**JINDAL ALUMINIUM LTD.**  
BANGALORE-560073 (INDIA)

| DESCRIPTION         | LADDER SECTION                     |

| DRAWING No. | SECTION No.   |
|-------------|---------------|
| 22546       | 22546-ISSUE-2 |

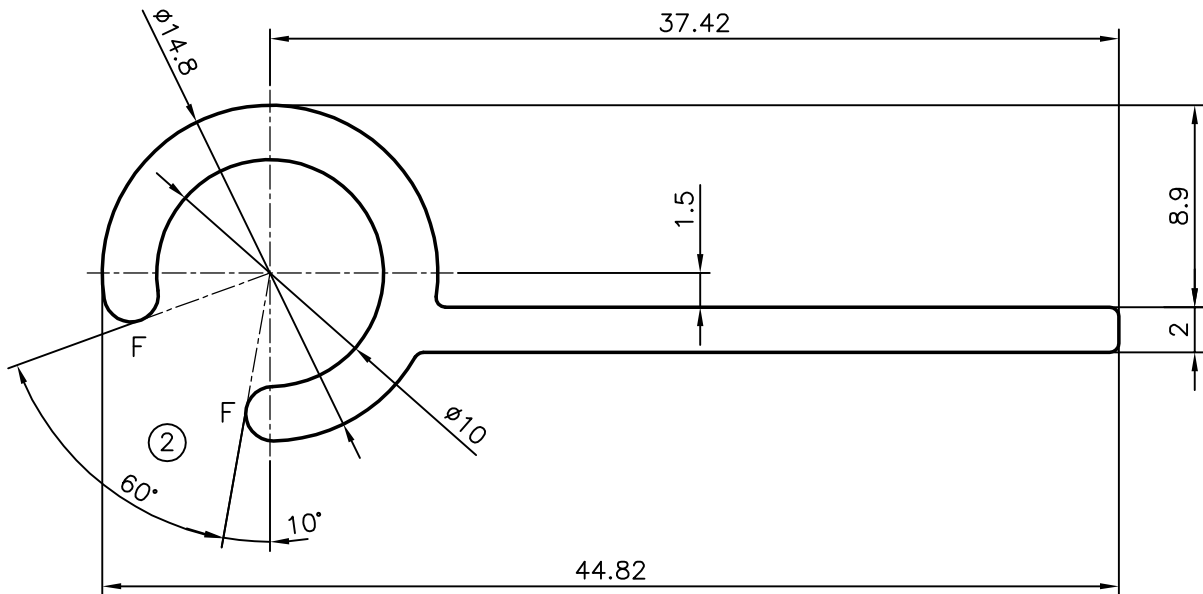
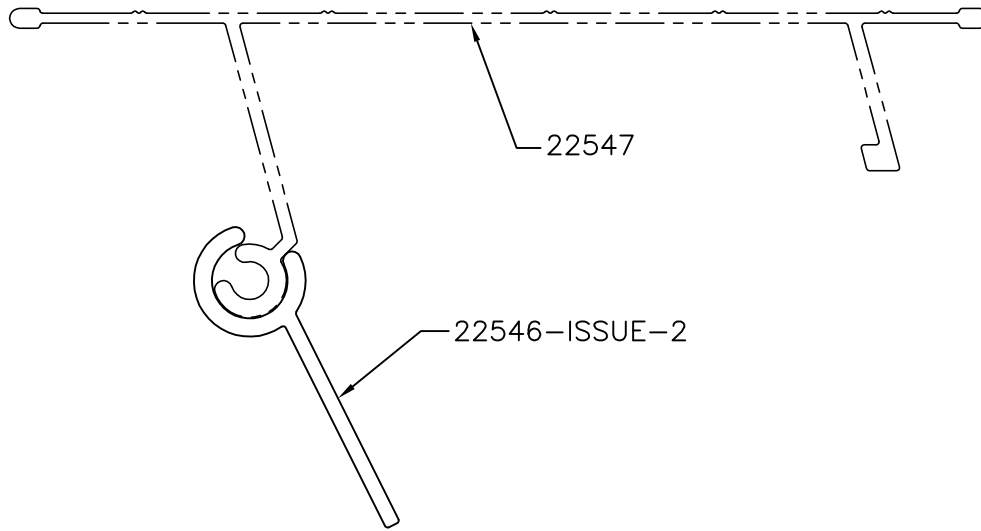
ISSUE -2 ANGLE CHANGED FROM 90° TO 60° &  
WEIGHT ALSO CHANGED FROM 0.350 kg/M TO 0.371 kg/M  
AS PER CUSTOMER REQUIREMENT
